PO Box 972, Cedar Ridge, CA 95924-0972
 www.cea-nc.org / email: info@cea-nc.org

IM Mine Potential Seismic Hazard March 20 , 2022

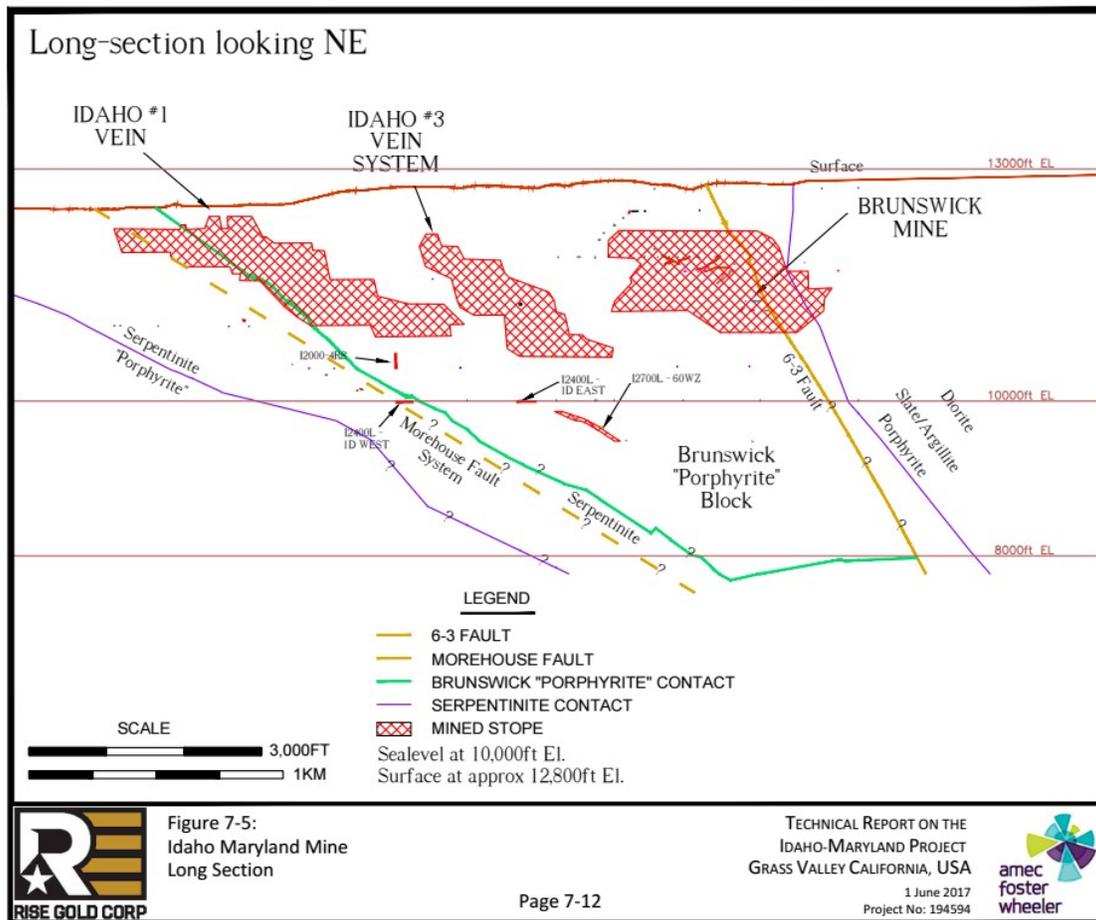
The mine project is targeting potential ore bodies that are more or less bounded by the Morehouse fault, the 6-3 fault (Weimar), and the Idaho fault. Within this zone are also numerous lesser faults, which are not shown in this image from pg 7-6, [I-M Tech Report](#). For reference, note that Wolf Creek, South Fork Wolf Creek, and the Brunswick Shaft near the corner of Brunswick Rd. and East Bennett Rd. are shown below.

Particularly noteworthy is the potential for seismic activity on the 6-3 fault in the region of the proposed Brunswick mine waste surface dumping site. The 2.2 million ton mine waste pile loads up the reverse thrust block side of the fault that is over the nearby planned mining operations.

This diagram shows the previous figure 7-5 cross section modified to show the approximate location of the 2.2 million tons of added fill on the right (east) side of the fault. The dewatering and removal of waste rock and ore will be mostly on the left (West) side of the fault.

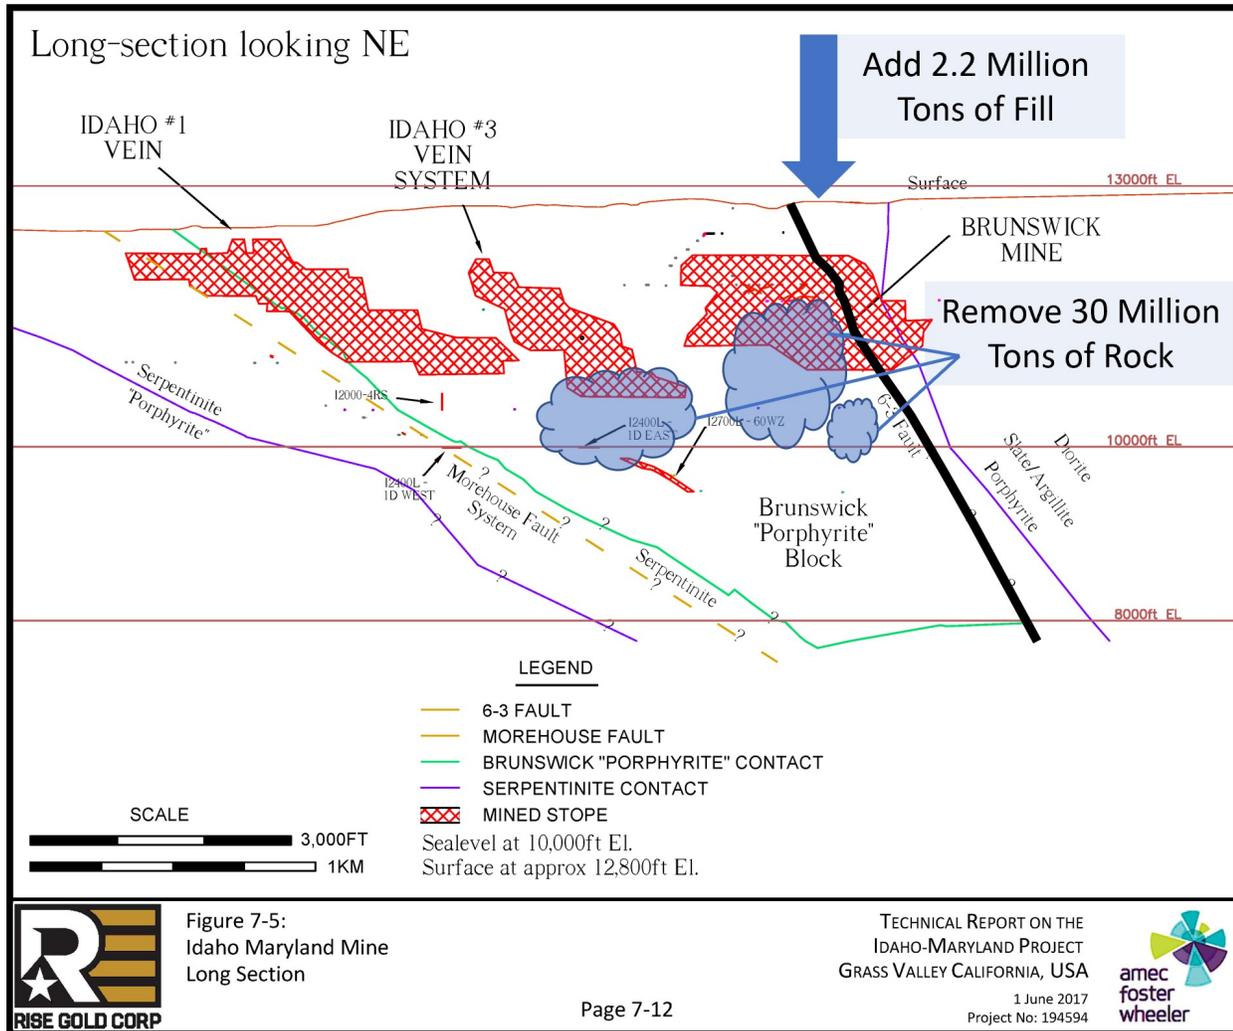
Throughout the 80 years of mining operations, expansion of mine works by tunneling and stoping will reduce the competency of the surrounding rock structure, vibrations from blasting will take place daily, and finally, at the end of mine operations, the mine will reflow, leading to a potential increase in the seismic activity due to the re-introduction of hydrostatic pressures.

A geological study of the seismic risks, including the risks from the proposed dewatering, mining, and mine waste dumping should be conducted and included in the DEIR addressing the following:

- How will the mining activities impact the seismicity of the area?
- Will the integrity of near surface historical and proposed mine works be impacted by loading?
- All buildings within the fault zones of the faults should be mapped in relation to the faults.
- An evaluation of the lesser faults as identified in the I-M Tech Report should be conducted.
